Product Change Notification

Product Change Notification: E-17-018606

General Product Description:
776231 35 Position AMPSEAL Vertical Header Assembly

776231-5 & 1-776231-5
KEY LOCATION
SCALE 2:1

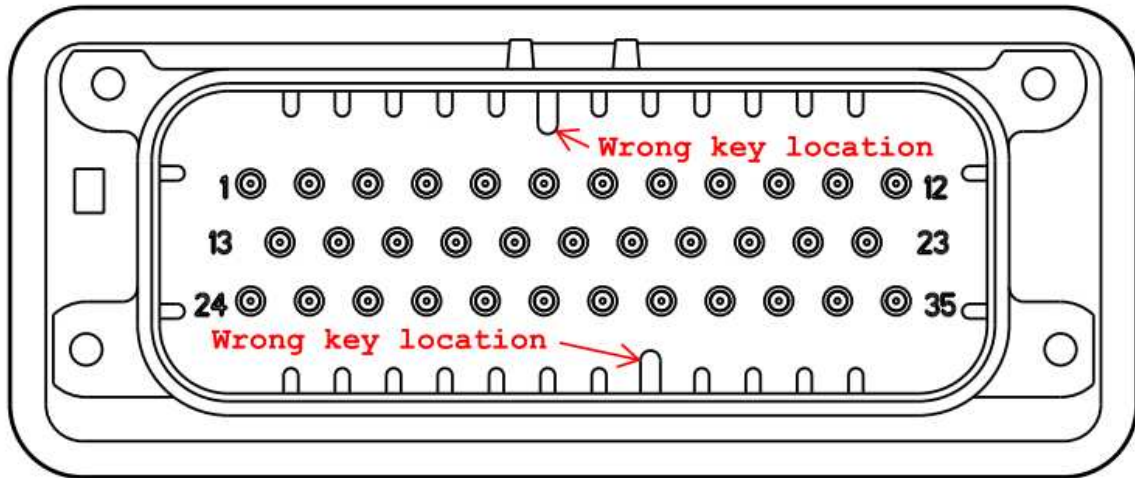
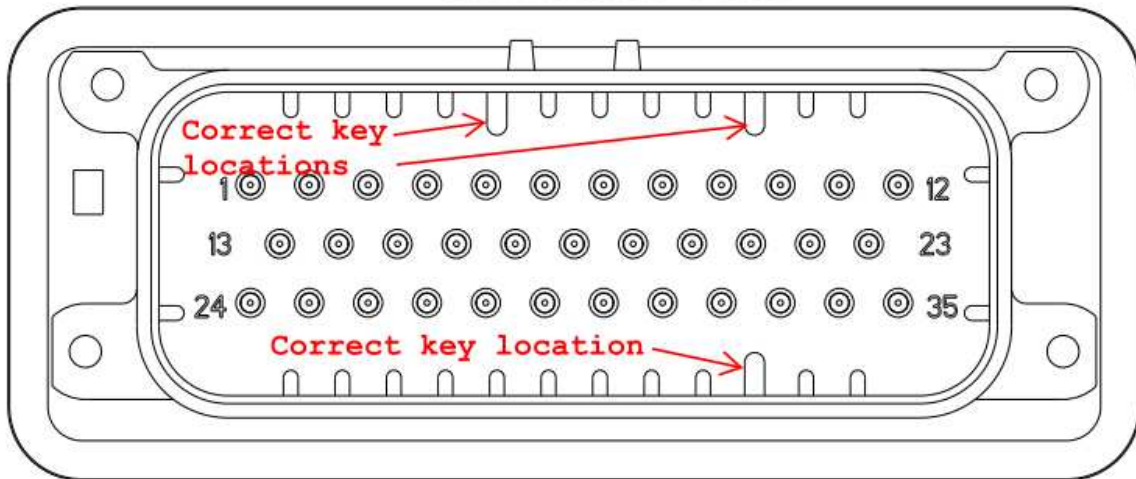
Description of Changes
The header view on Sheet 2, Zone A-7/8 did not show the correct keying for PNs 776231-5 and 1-776231-5. Updated this view to show the correct keying inside the header shroud The drawings for the listed part numbers have been modified to correct following; Before: After:
Other attachments:
PCN-17-018606

Current incorrect key locations

Corrected view

776231-5 & 1-776231-5
KEY LOCATION
SCALE 2:1
